MODELLI / MODELS : BREADMAKERS - BM250 / BM256

OGGETTO: CHANGES TO BREADPANS, KNEADERS AND HUB ASSEMBLIES
SUBJECT :

10 GUIGNO (IT) / 10 JUNE (UK) 2015

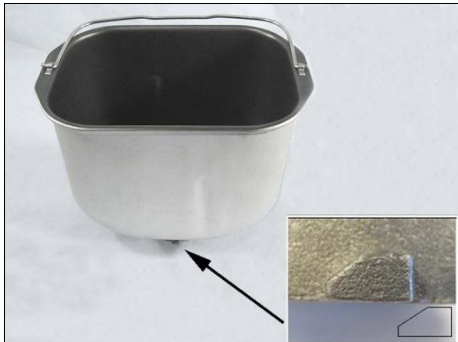
BREAD PAN

Non Twist and Lock	Twist and Lock Type 2

KW702945	KW713201
Up to 09H25 (BM250)	From 09H25 to 13B08 (BM250)
Up to 09F21 (BM256)	From 09F21 to 13B08 (BM256)
168mm tall breadpan	168mm tall breadpan
(Internal vertical location lugs)	(Flat lug / No seal in hub)
Twist and Lock Type 3

KW715072	
From 13B09 onwards (BM250 / BM256)	
168mm tall breadpan	
(Small angled lead in / with seal in hub)

HUB

Non Twist and Lock Hub	Twist and Lock Type 2

KW712165	KW712261
Up to 09H25 (BM250)	From 09H25 to 13B08 (BM250)
Up to 09F21 (BM256)	From 09F21 to 13B08 (BM256)
(vertical slots)	(No seal)
Twist and Lock Type 3

KW714131	
From 13B09 onwards (BM250 / BM256)	
(with seal)

KNEADER

KW702957

Up to 09H25 (BM250)

Up to 09F21 (BM256)

10mm shaft

KW712246

From 09H25 onwards (BM250)

From 09F21 onwards (BM256)

8mm shaft
